AS LISTED SYSTEM V CONTROL (DIGITAL)

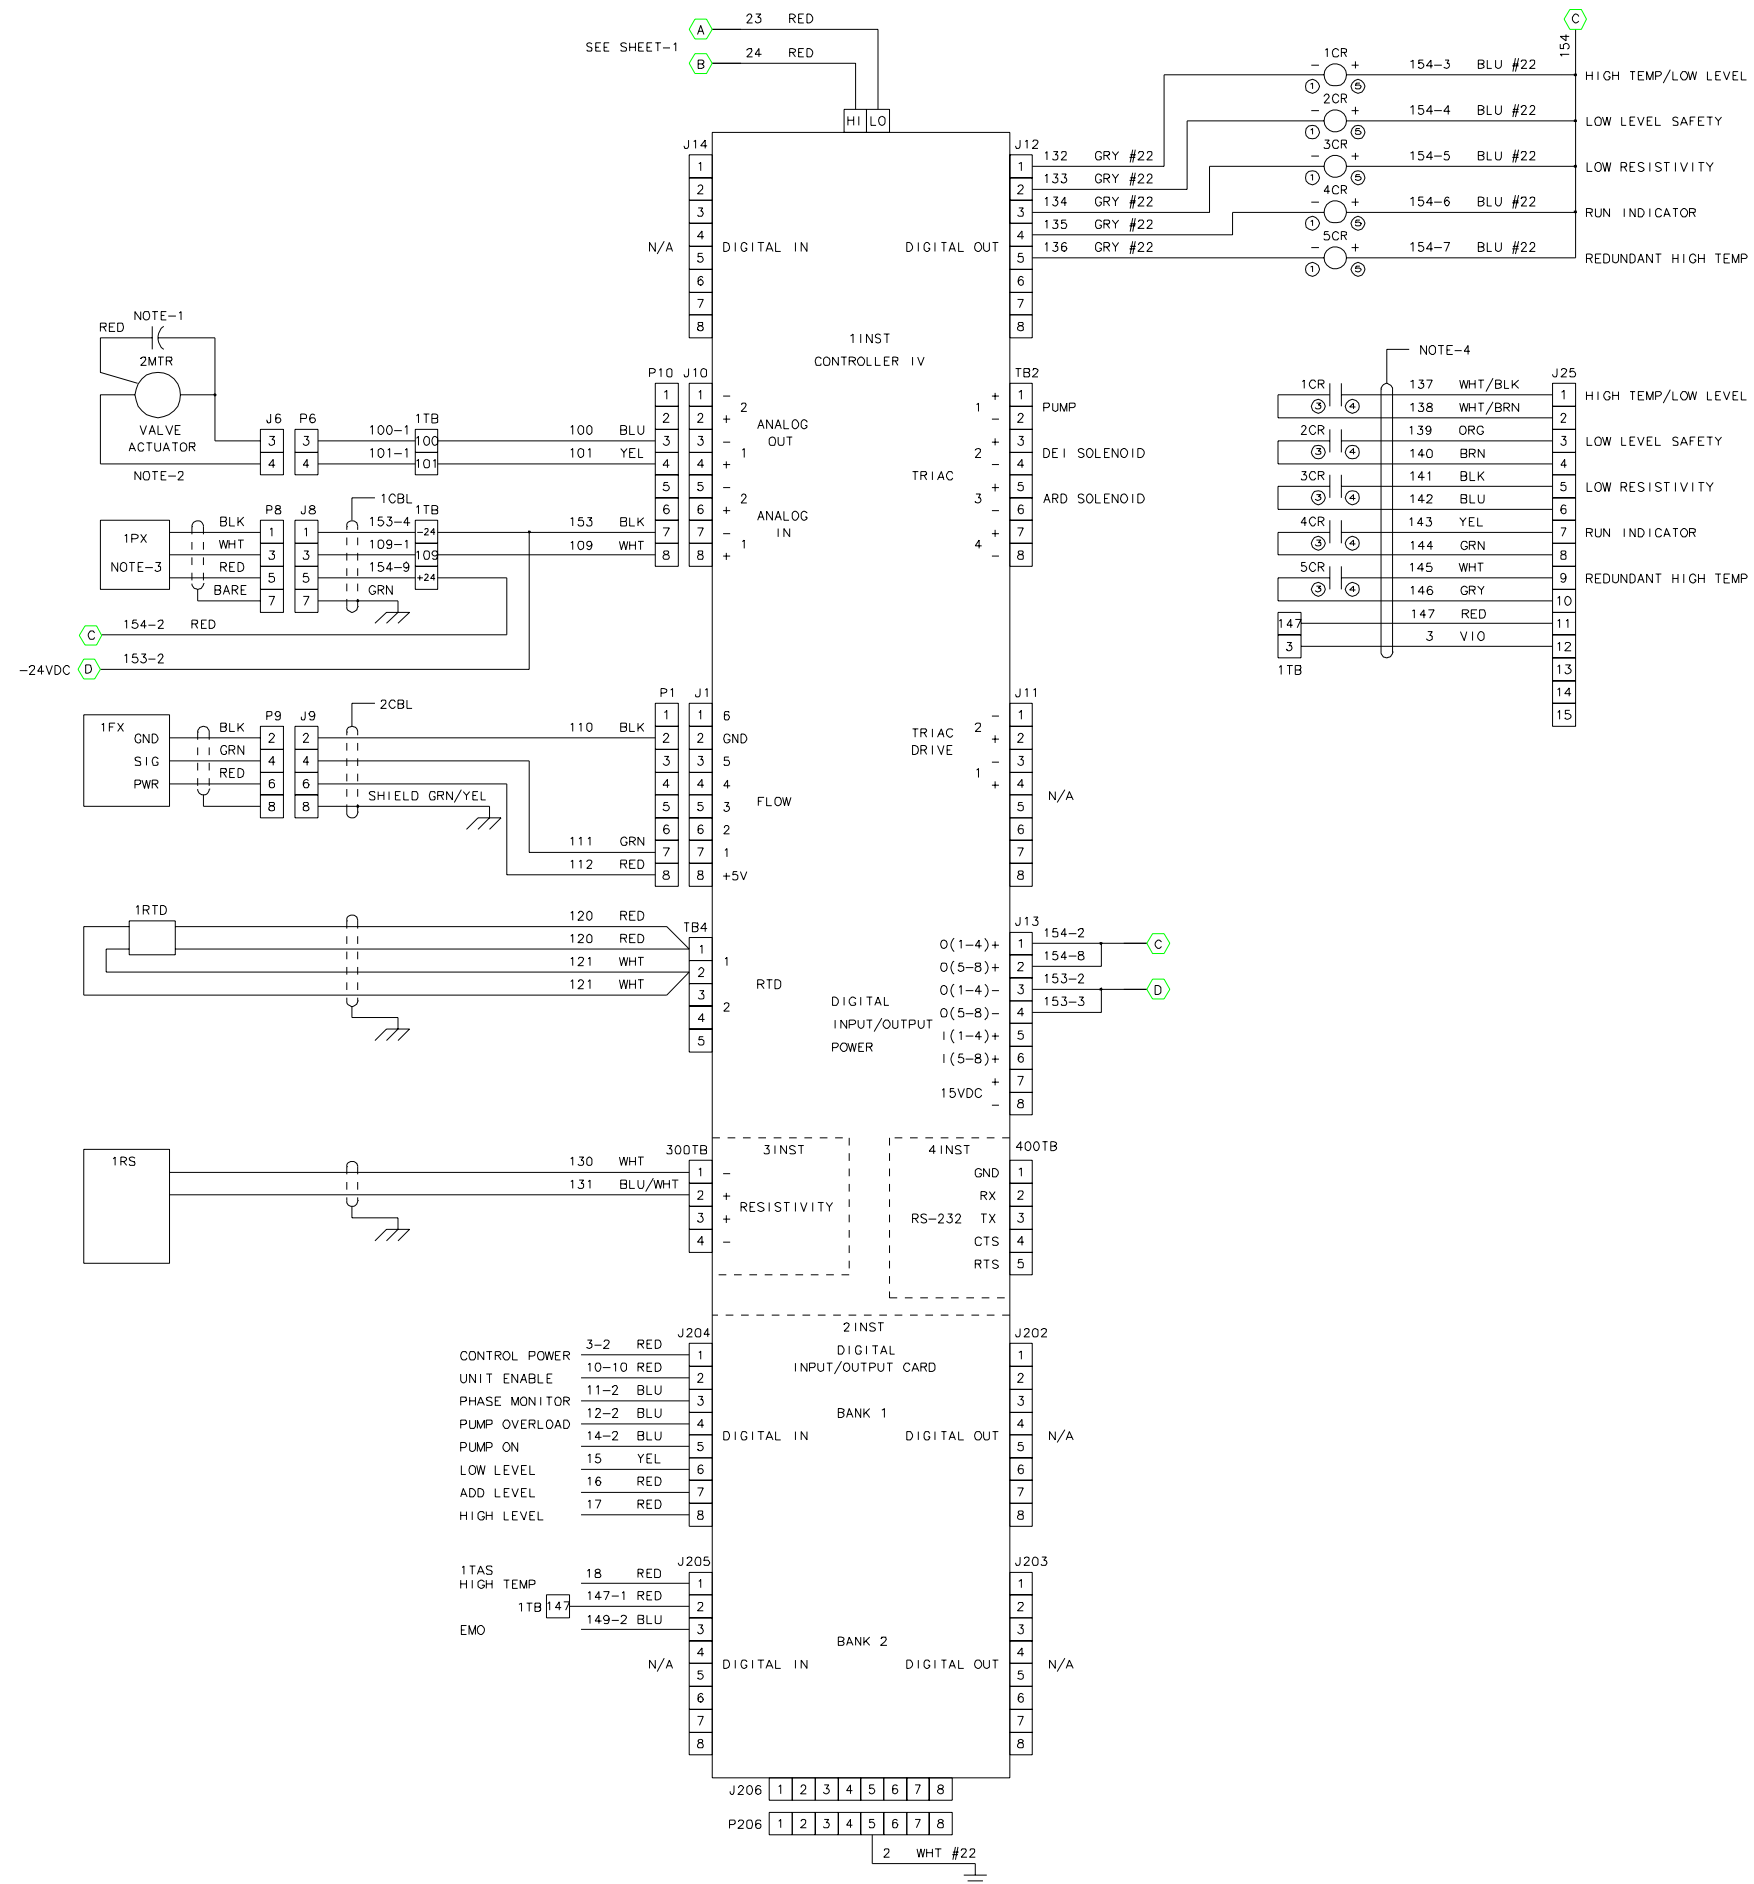
C7B6	A	ADDED: GND TO 1PWS AND 2MTR; VARIOUS WIRE NOS. . . COLORS AND GAGES; P/J6-1,2; P/J5-1	3-18-98	BAJ	DS	DS
A8	B	CHANGED: TB2 WAS 2TB; P/J5-2 WAS P/J4-3; 11L1,2,3 WAS 8L3,2,1; 12L3 WAS 1L3.				
C4A7	C	ADDED: GROUND TO 1TAS; WIRE NUMBERS TO 1PWS L1 AND L2 WIRES. CHANGED: "SYSTEM ON" WAS "PUMP STATUS"; WIRE NUMBER 2L1-1 WAS 2L1-2; NOTE-3 WAS "LAST WIRE NUMBER '15 152'"; PCO 11652	6-5-98	BAJ	AK	LG
A7	D	CHANGED: 2C1 P/N WAS 014687; J25 WAS 006669. ECO 13743	7-15-99	BAJ	CLG	CAD
B6	E	ADDED: 1,2CBL, P/J4-6, P/J8,9 TO P/L; 1PWS L1 AND L2 WIRES. CHANGED: "SYSTEM ON" WAS "PUMP STATUS"; WIRE NUMBER 2L1-1 WAS 2L1-2; NOTE-3 WAS "LAST WIRE NUMBER '15 152'"; PCO 11652	11-5-99	BAJ	JCH	CWC
D4	F	CHANGED: 1TAS WAS SHOWN "OPEN ON RISE". DELETED: 3SOL GROUND WIRE. ECO 15741	1-30-01	BAJ	RBL	APC
A6, B7	G	ADDED: 1TB TO WIRE #9L3, 12L3, 15-18; CONNECTION POINT TEXT TO 1CON, 1,2MOL; VARIOUS WIRE NUMBERS AND COLORS. ECO 17052	8-02-02	BAJ

REV	DESCRIPTION	DATE	BY	CHK	APP
A	ADDED: VARIOUS WIRE NOS., COLORS AND GAGES; NOTE-4; P/J6 BETWEEN P10 AND 2MTR. CHANGED: TB4 WAS 4TB; TB2 WAS 2TB; 111 GRN WAS 111 CLR. PCO 10653	3-18-98	BAJ	LG	LG
B	ADDED: NOTE-5. PCO 11652	6-5-98	BAJ	AK	LG
C	NO CHANGES. SEE SHEET-1 FOR REVISION. ECO 13743	7-15-99	BAJ	CLG	CAD
D3	DELETED: NOTE-5 WAS "J25 IS AN IDC MALE CONNECTOR". ECO 13971	9-7-99	BAJ	---	CAD
C6 B6	E ADDED: P/J8; P/J9; "22AWG, 15C" TO NOTE-4. CHANGED: WIRE NO. 131 WAS BLK. ECO 14056	11-5-99	BAJ	JCH	CWC
F	NO CHANGES. SEE SHEET-1 FOR REVISION. ECO 15741 & ECO 15617	1-30-01	BAJ	RBL	APC
C6 C4 A6 B4	G ADDED: 1TB TO WIRE #100, 101, 109, 153. 154-9 CHANGED: 1TB-147 WAS J205-2; 1TB-3 WAS J204-1; 1TB-147 WAS J25-11; WIRE NUMBERS TO 11INST-J13. ECO 17052	8-02-02	BAJ
